Product/Process Change Notice (PCN)

PCN_IndTPC_2828_ThicknessCarrierTape:

Product Affected: WE-TPC 2828 series

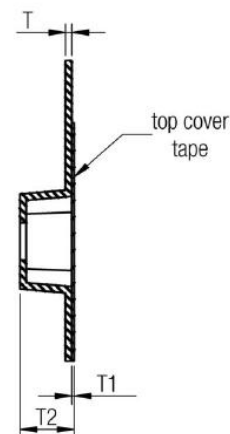
Due to the improvement of our product quality, the carrier tape thickness will change from 0.25 mm to 0.4 mm.

The new dimension of the tape thickness will be mentioned in the datasheet with the abbreviation of a "T".

BEFORE "T" = 0,25 mm.

AFTER "T" = 0,40 mm.

In consequence of this change will be also affected the thickness of T2. Hence, T2 will change from 1,60 mm to 1,75mm.

BEFORE "T2" = 1,60 mm.

AFTER "T2" = 1,75 mm.
